UNITED STATES PATENT AND TRADEMARK OFFICE

APPLICATION NO.	FILING DATE	FIRST NAMED INVENTOR	ATTORNEY DOCKET NO.	CONFIRMATION NO.
09/939,516	08/24/2001	John B. Harvey	26346-1	2442

Office Action Summary

DETAILED ACTION

wherein the land has a first pair **A** (Figures 5 and 6 reprinted below with annotations) of planar alignment surfaces;

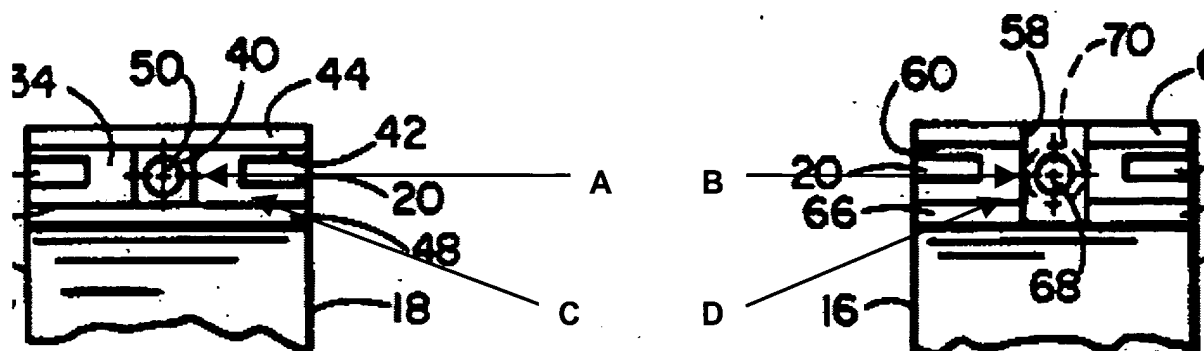
a recess **58** projecting into the second mating surface wherein the recess is centrally disposed inward from the outer edges **16,18** of the second mating surface such that upon engagement of the first semi-circular member with the second semi-circular member, the recess is hidden inside of the cylindrical body;

wherein the recess has a second pair **B** of planar alignment surfaces complimentary to the first pair of planar alignment surfaces wherein contact of the first pair of planar alignment surfaces with the second pair of planar alignment surfaces when the land is received in the recess provides axial alignment of the first semi-circular member with the second semi-circular member;

wherein the land has a third pair **C** of planar alignment surfaces; and

wherein the recess has a fourth pair **D** of planar alignment surfaces complimentary to the third pair of planar alignment surfaces wherein contact of the third pair of planar alignment surfaces with the fourth pair of planar alignment surfaces when the land is received in the recess provides radial alignment of the first semi-circular member with the second semi-circular member (Figures 1-6).
